PRAIRIE ISLAND NUCLEAR GENERATING PLANT UNIT NO. 1

Amendment No. 29  
License No. DPR-42

Amendment No. 23  
License No. DPR-60

SAFETY EVALUATION BY THE OFFICE OF NUCLEAR REACTOR REGULATION  
SUPPORTING AMENDMENT NO. 29 TO FACILITY OPERATING LICENSE NO. DPR-42  
AMENDMENT NO. 23 TO FACILITY OPERATING LICENSE NO. DPR-60  
NORTHERN STATES POWER COMPANY  
PRAIRIE ISLAND NUCLEAR GENERATING PLANT UNIT NOS. 1 AND 2  
DOCKET NOS. 50-282 AND 50-306

HOT CHANNEL FACTOR NORMALIZED

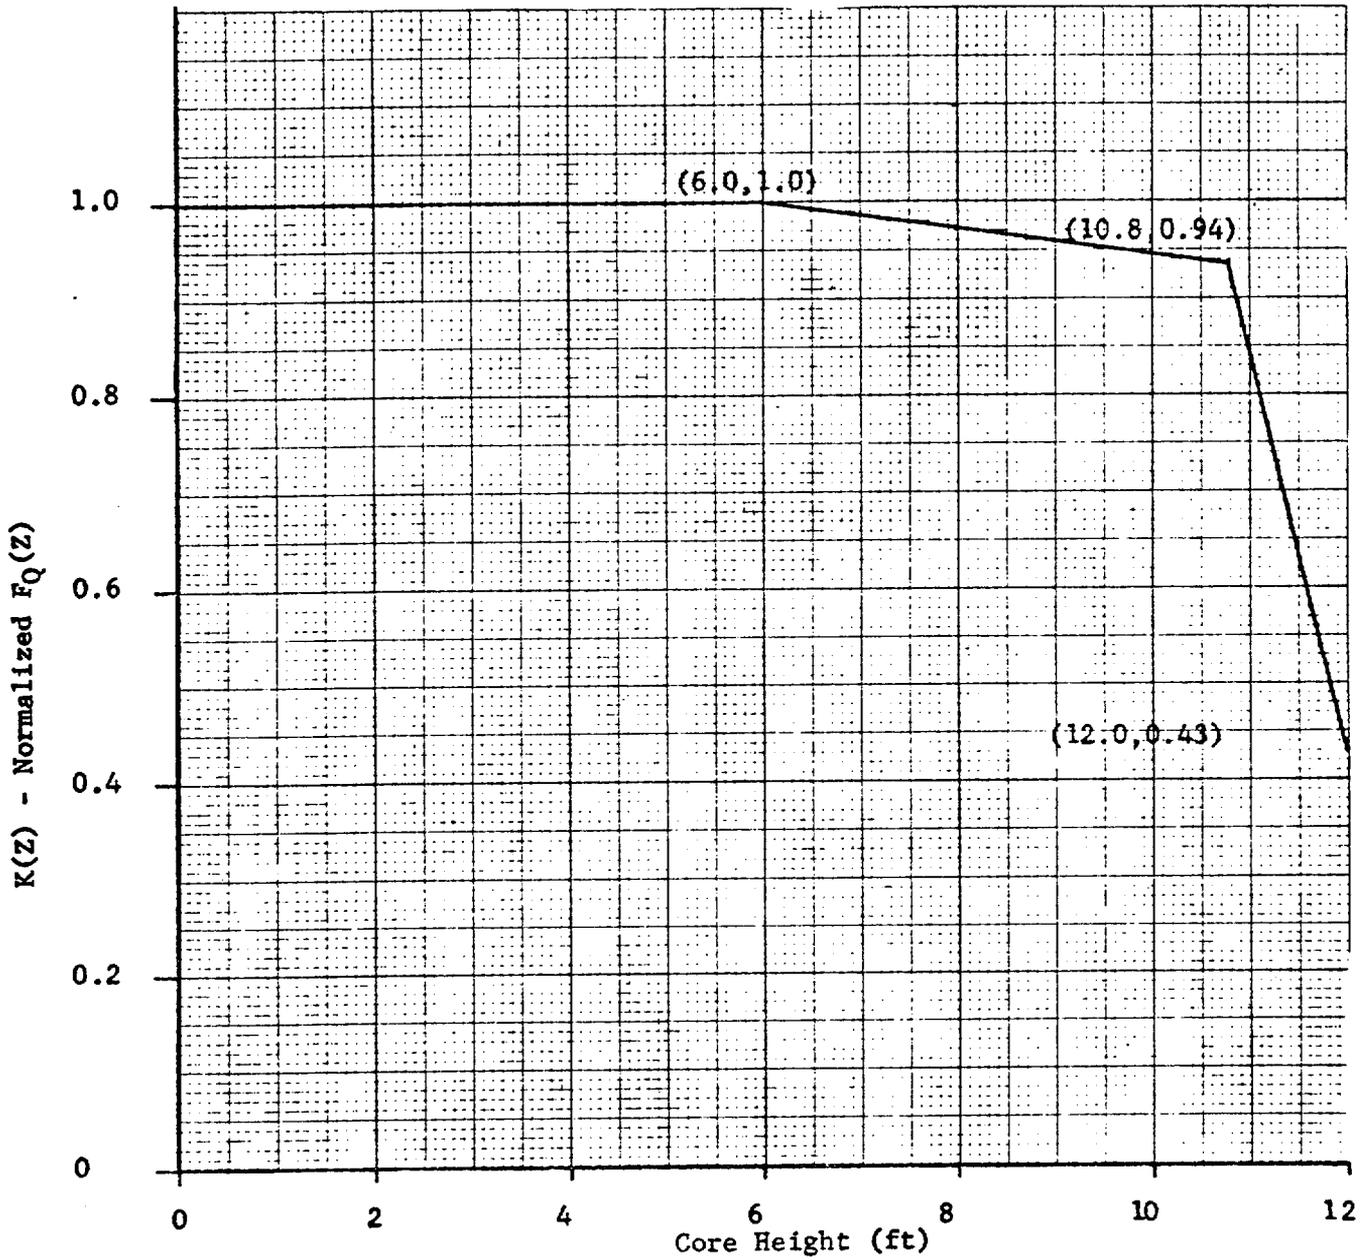
Items 7, 8 and 9 provide the bases for the changes in the Technical Specifications and submitted additional figures needed for the changes discussed above. Proposed Figure TS 3.10-5 is a graphical representation of the function  $K(Z)$  used in the calculation of  $F_0^N$  consistent with the new approved LOCA analysis.<sup>(1)</sup> Proposed new Figure TS 3.10-7 is a graphical representation of the rod bow penalty function RBP(BU) proposed for use in calculating  $F_{\Delta H}$ . The function RBP(BU) is consistent with our evaluation<sup>(8)</sup>. The present Figure TS 3.10-7 has been proposed for deletion since it does not constitute a limiting condition for operation. We agree that this figure is informational in nature and that it can be eliminated with no technical impact. We find that the changes requested in Items 7, 8 and 9 are therefore acceptable.

where P is the fraction of full power at which the core is operating. K(Z) is the function given in Figure TS.3.10-5 and Z is the core height location of  $F_Q^N$ . RBP(BU) is the Rod Bow Penalty as a function of region average burnup as shown on Figure TS.3.10-7, where region is defined as those assemblies with the same loading date (reloads) or enrichments (first cores).

ROD BOW PENALTY (RBP) FRACTION  
VERSUS REGION AVERAGE BURNUP

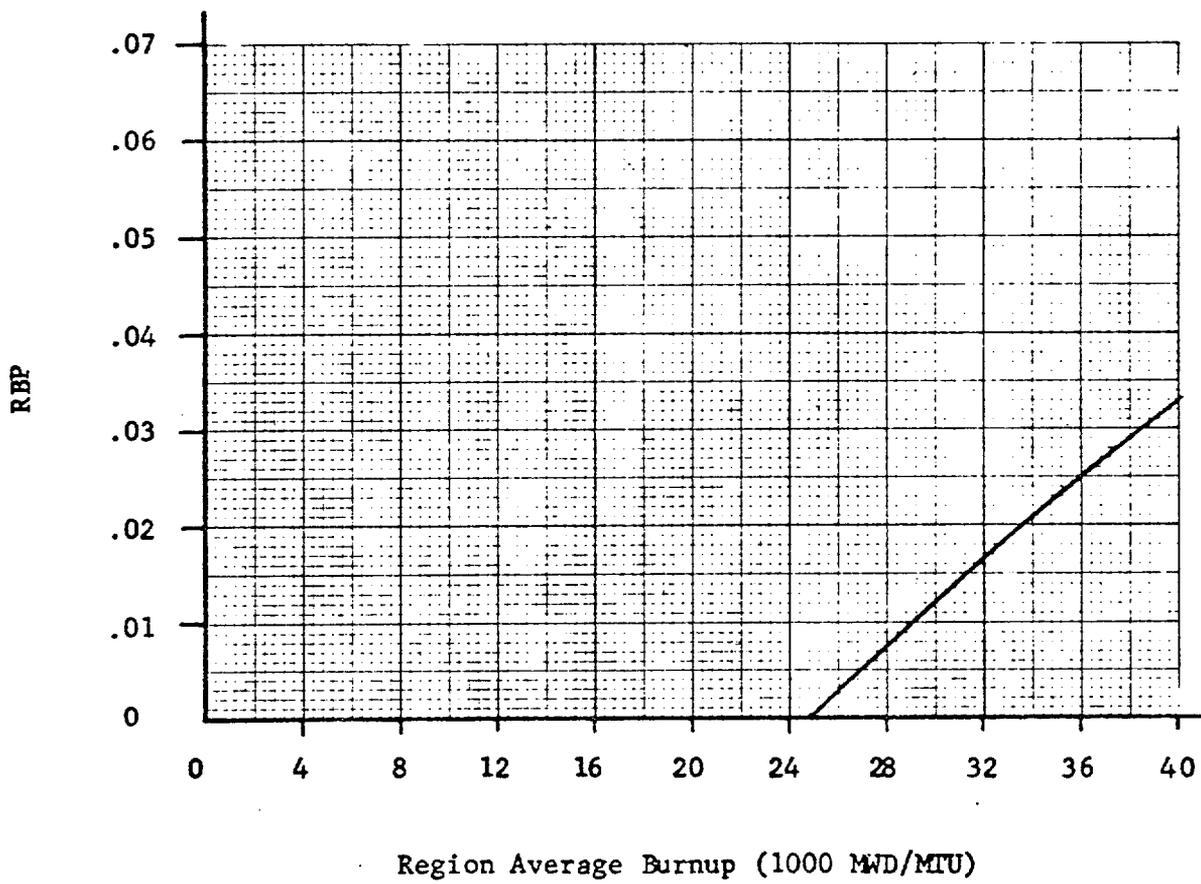
RBP(BU) is a rod bow penalty which varies as a function of burnup as shown in proposed Technical Specification Figure 3.10-7. In addition we conclude that the following definition should be included in Specification 3.10.B.1:

"RBP(BU) is the Rod Bow Penalty as a function of region average burnup as shown on Figure TS.3.10-7, where region is defined as those assemblies with the same loading date (reloads) or enrichments (first cores)."
